SR-2 – STAFF ADVISORY REPORT (04-03-2026) Revised 04/06/2026

ADDRESS: 4221 CORTLAND

APPLICATION NUMBER: HDC2026-00097

SCOPE: REBUILD REAR AND SIDE WALLS OF REAR WING; INSTALL FRONT PORCH RAILING

Applicant photo of 4510 Cortland. This is the railing proposed for installation at 4221 Cortland.

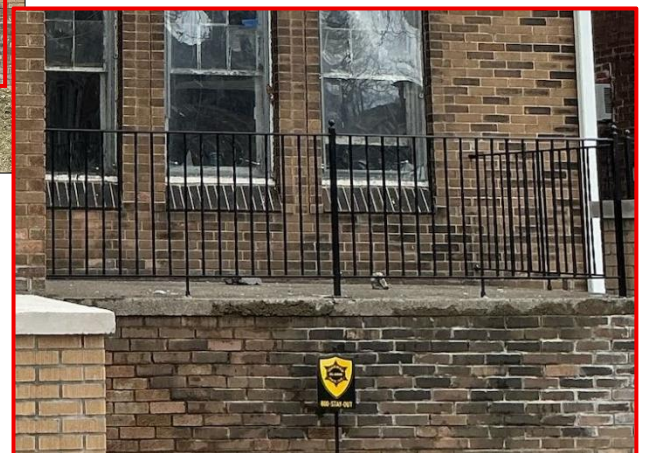
- The installation of a 36” high railing at the front porch does not match the low height of the historic railing that was removed without HDC approval. The taller metal railing would project (or extend) above the height of the windowsill at the first floor and would not provide an appearance that is appropriate to the early 20th century historic and architectural character of the dwelling, thus altering the features and spaces that characterize the property.

- **The applicant proposes to install a straight spindle metal railing with narrow posts with ball caps, identical to the railing installed at 4510 Cortland (shown below). Staff notes the railing at 4510 Cortland had been installed without HDC approval and was reviewed by the Commission after the fact, at its August 13, 2025 meeting. HDC staff recommended denial of the railing; the Commission issued a COA (HDC2025-00485) for the railing as installed.**

Applicant photo. With exception of the deteriorated section of the wall, the historic age wood siding on the remaining walls appeared to be intact and in repairable condition.

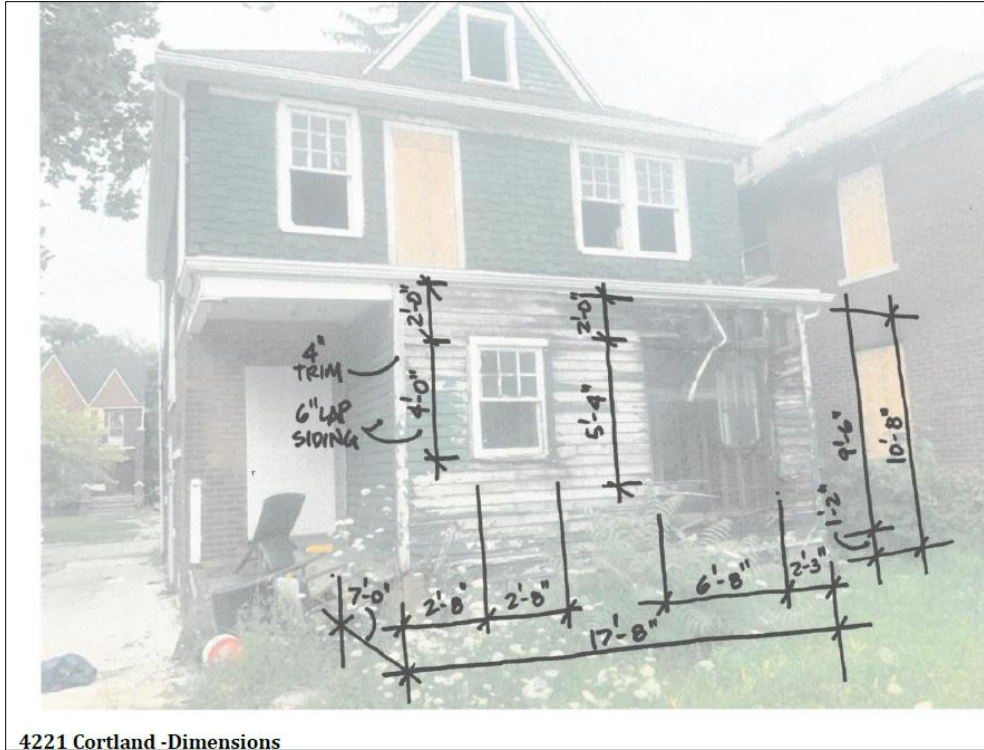
- The applicant is proposing to install LP SmartSide Primed, "brushed smooth" finish, 6" lap siding, installed with a 4-1/2" exposure. This would replace the historic age wood siding that had been in place prior to the removal of the two walls.

- The manufactured composite product does not match the depth, profile, and shadow lines of the previously installed historic wood siding. Installing the substitute product on walls of a historic feature/location, as opposed to being used on new construction (such as an addition or free-standing structure), would create a loss of authenticity and the physical features and characteristics closely associated with the property’s historic significance would be altered.

Applicant diagram of the previously existing dimensions.

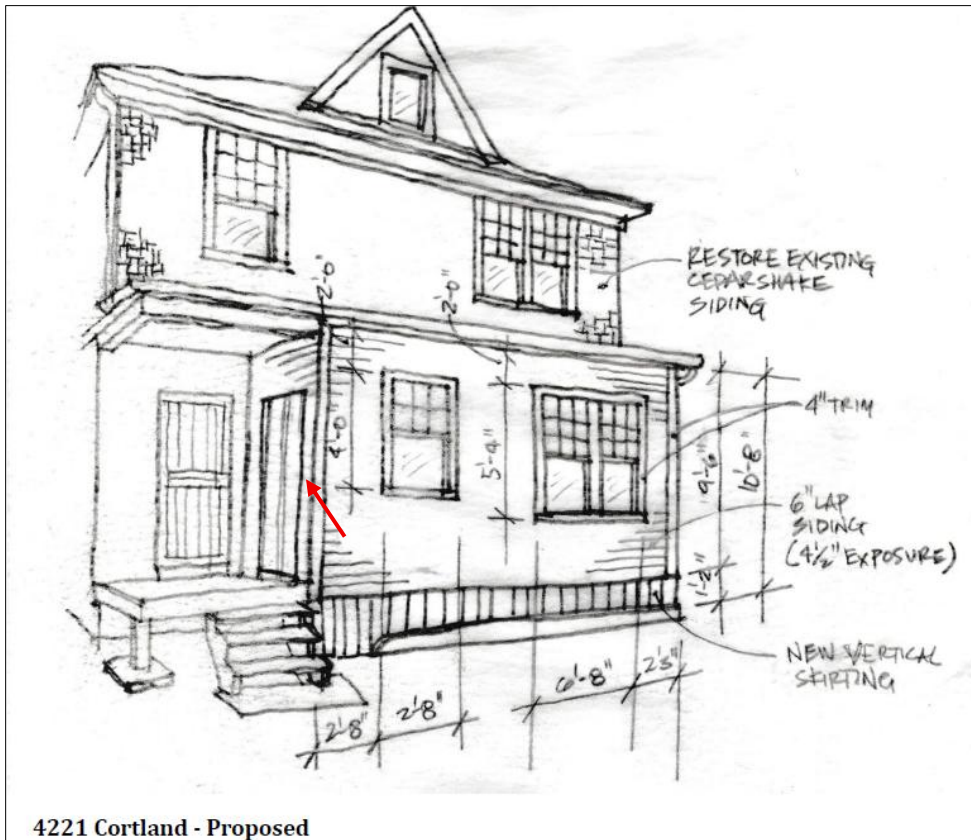
Applicant's proposed design. The opening on the side wall denotes a double door or French door, approved by staff in 2022 (COA 22-7760). Also approved within this COA was the repair and reinstallation of the existing wood windows.
